RECORD SET

FACILITY PLAN

CLEAN HARBORS ENVIRONMENTAL SERVICES  
1340 WEST LINCOLN STREET  
PHOENIX, ARIZONA  
PHONE: (602) 258-6155 FAX: (602) 258-8353

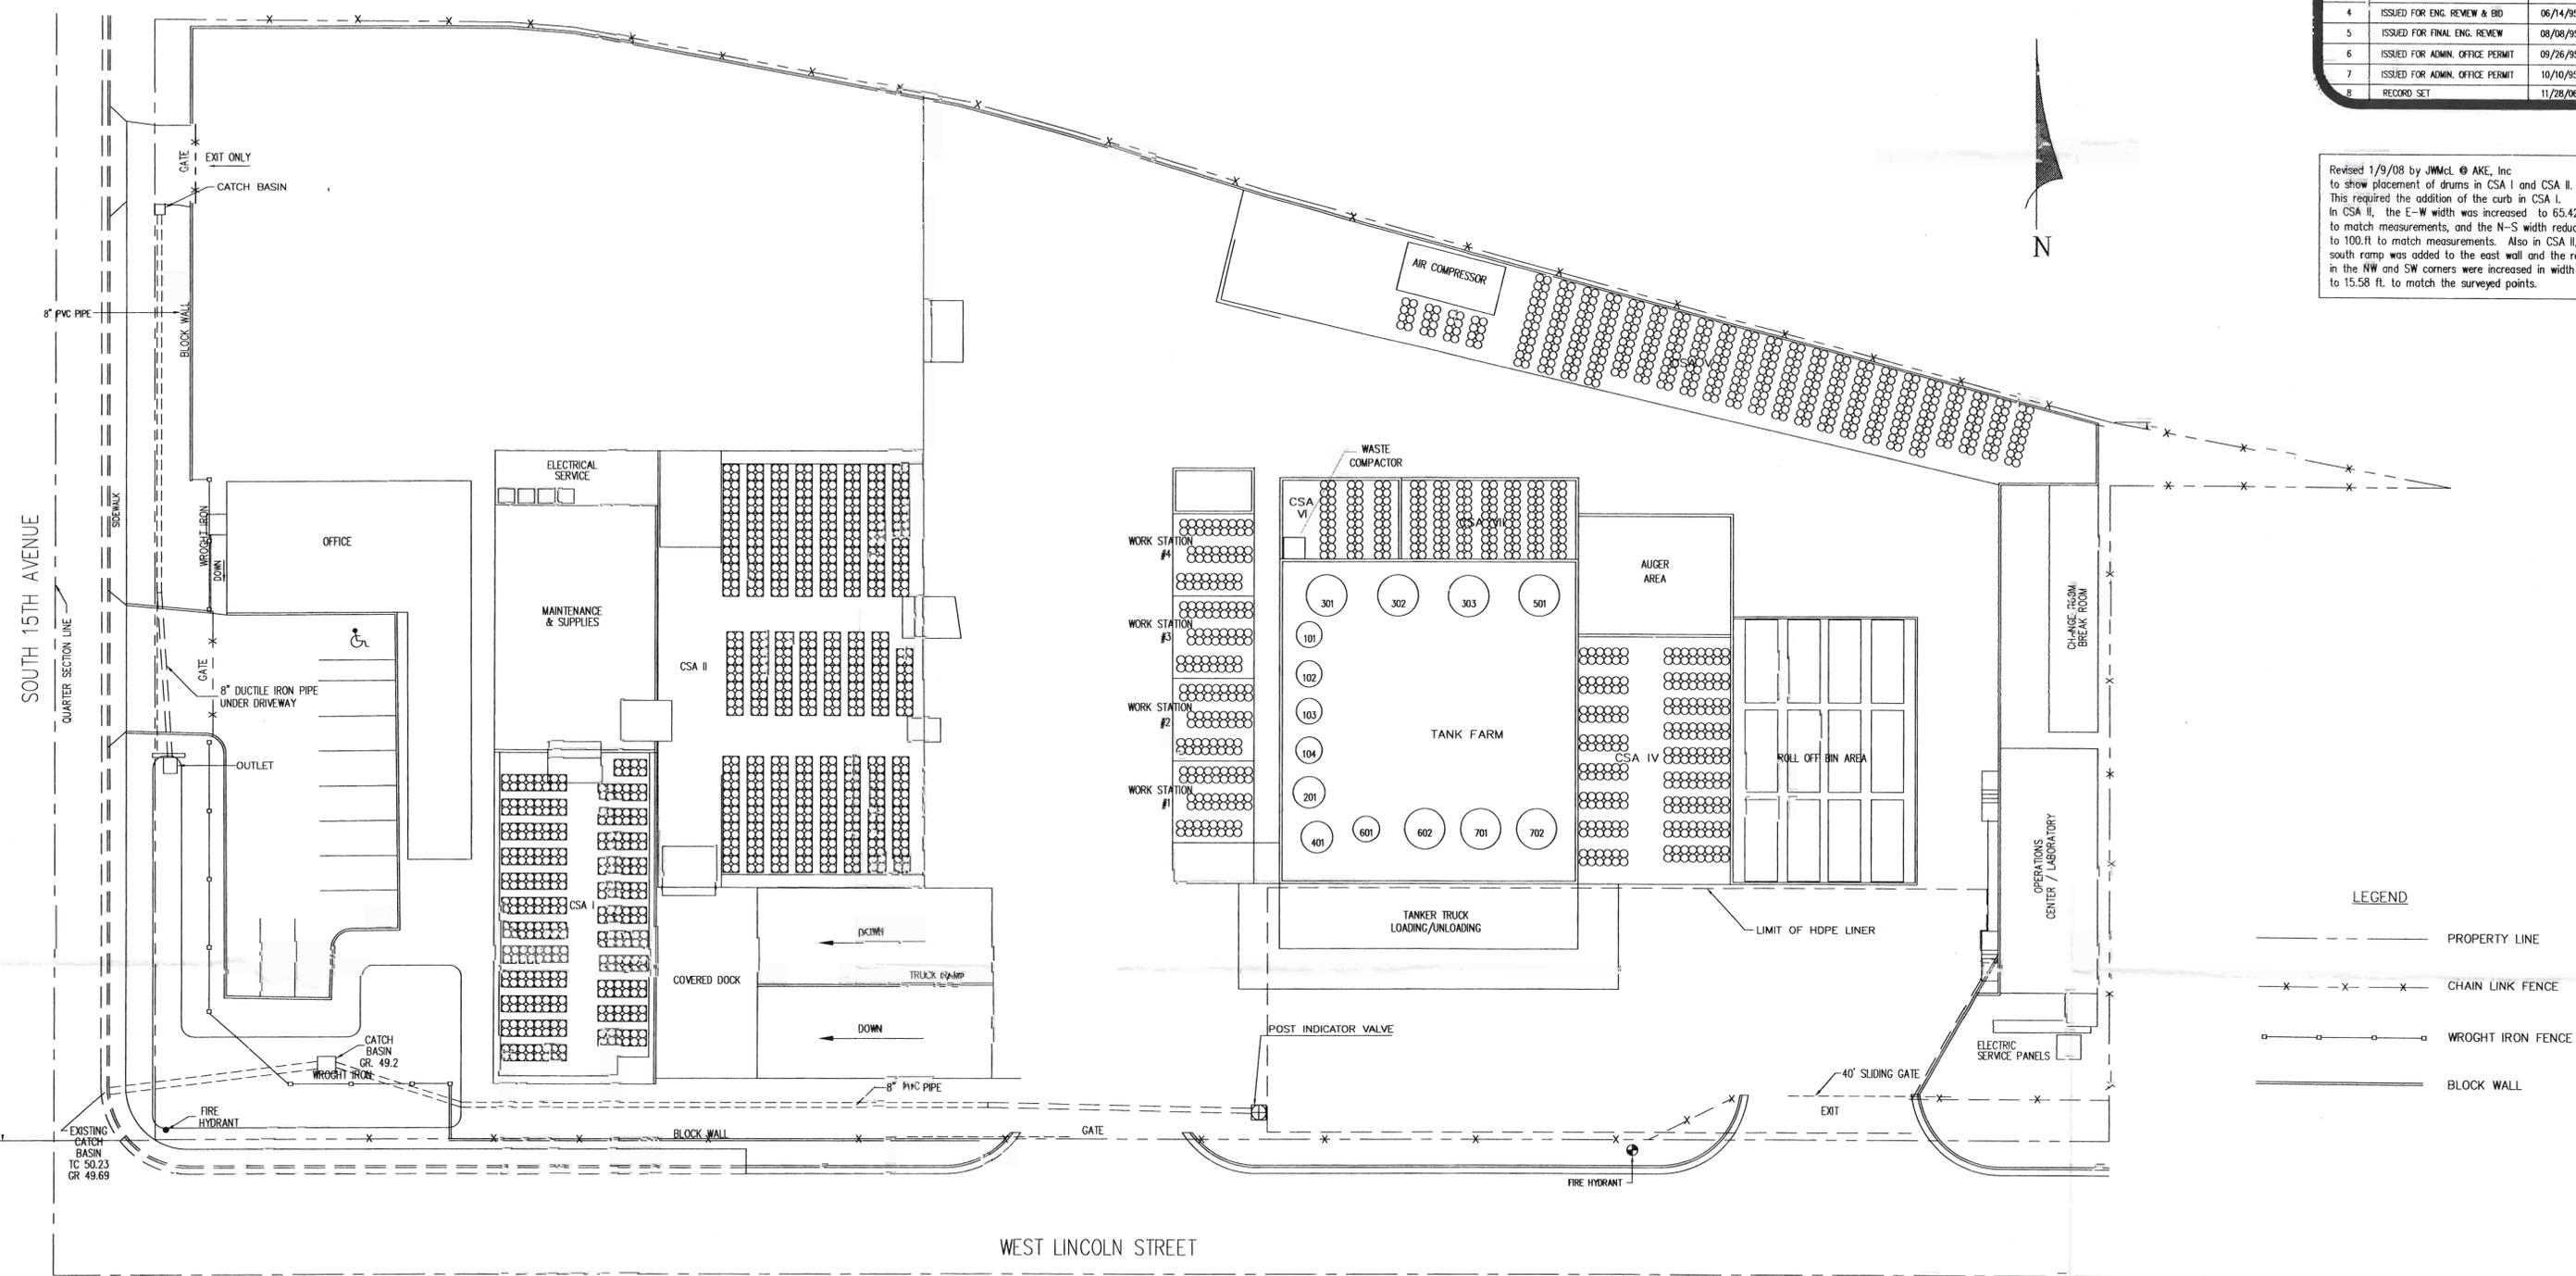
Revised 1/9/08 by JMMcL © AKE, Inc to show placement of drums in CSA I and CSA II. This required the addition of the curb in CSA I. In CSA II, the E-W width was increased to 65.42 ft to match measurements, and the N-S width reduced to 100.0 ft to match measurements. Also in CSA II, the south ramp was added to the east wall and the ramps in the NW and SW corners were increased in width to 15.58 ft. to match the surveyed points.
